TECHNICAL INFORMATION

BCU Sleep-mode Troubleshooting and Upgrade

No: 86/01/01/NAS
Ref:
Issue: 1
Date: 02/16/01

Discovery Series II (LT)

Figure 1

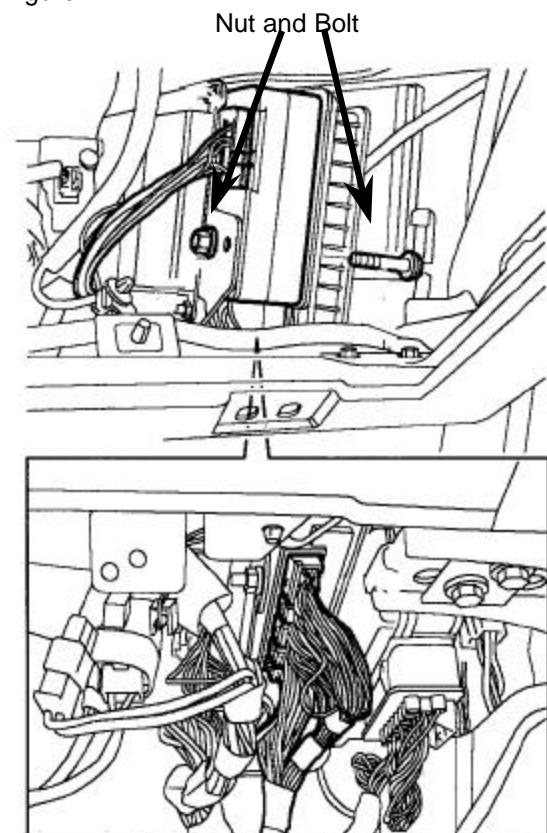
4. Remove trim clips (fir trees) and remove lower trim panel above passenger footwell.
5. Disconnect four connectors on BCU accessible through the trim panel.
6. Open the glovebox and swing down completely.
7. Disconnect power connector on BCU.
8. Remove nut and bolt (10mm) securing BCU into bracket assembly. (Figure 1)
9. Remove BCU.
10. Reinstall new BCU.
11. Reconnect vehicle battery.

Figure 2

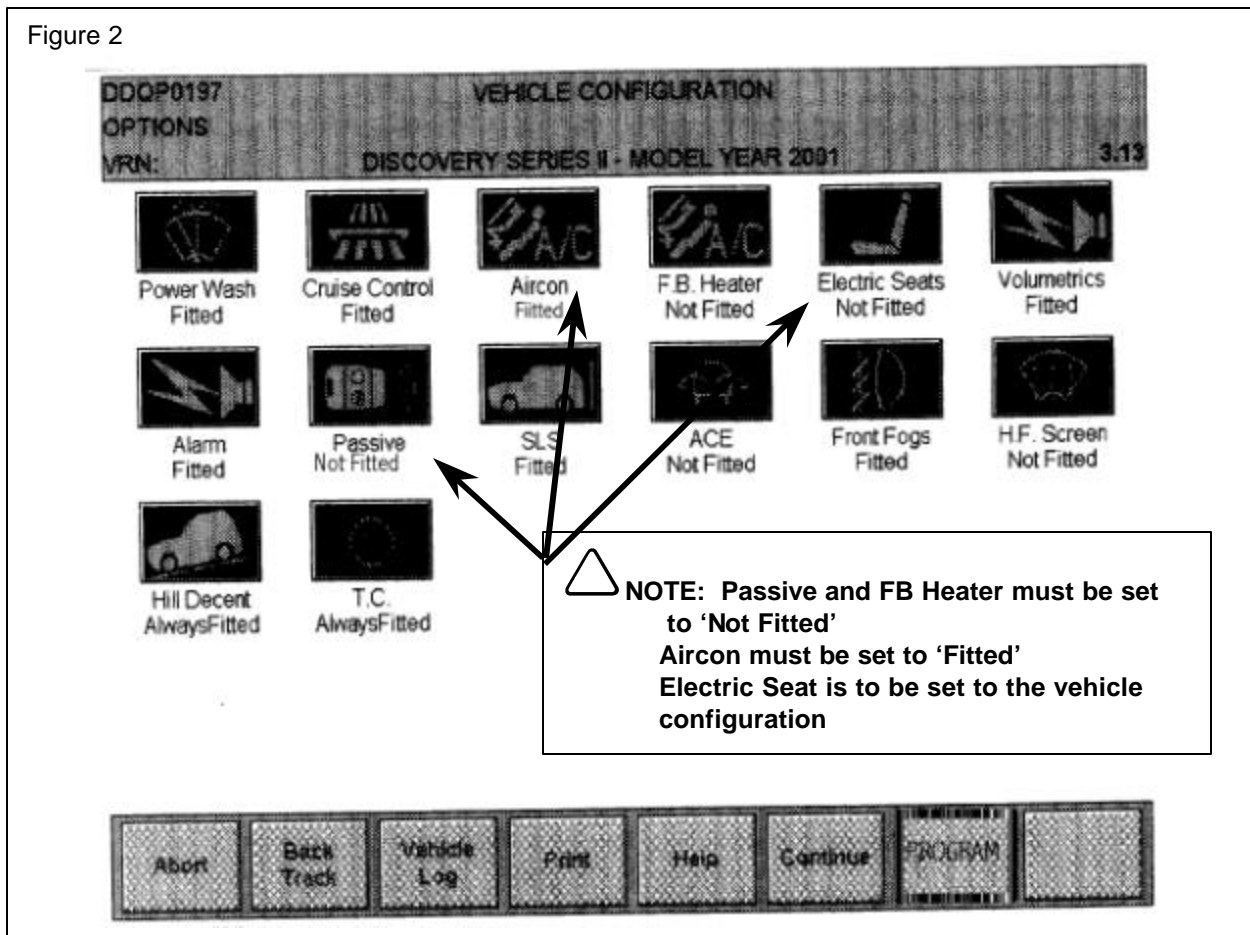
NOTE: TestBook will display a page of buttons for each selectable vehicle option on the Vehicle Configuration Page. Figure 2 shows the displayed selectable buttons.

9. Press each button as necessary to turn options on and off.
10. Verify that "Passive Immobilization" and "F.B. Heater" are toggled to the "NOT FITTED" status.
